GOVERNMENT OF INDIA
MINISTRY OF ENVIRONMENT & FORESTS
Central Zoo Authority

F. No. 19-256/93-CZA(193)(Vol. III)(M)/2437

Sub:- Proposed design for the construction of various enclosures at Nagaland Zoological Park, Rangapahar.

The designs for the construction of various enclosures at Nagaland Zoological Park, Rangapahar was placed before the Meeting of the Expert Group on Zoo Designing of the Central Zoo Authority held on 1st March 2013.

BARKING DEER EXHIBIT (LAYOUT PLAN)

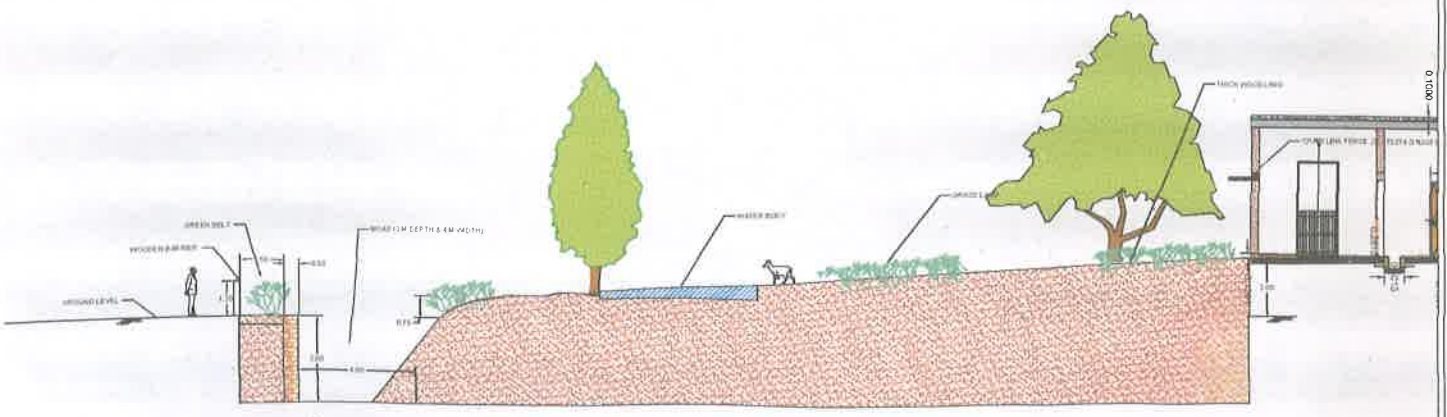
4. Barking deer exhibit

- (i) The kraal to be kept outside the paddock area.
- (ii) The entry from paddock to the kraal should be made from feeding cells.
- (iii) Viewing area for visitors should be shifted on a side, and any case should not be kept opposite to feeding cells.
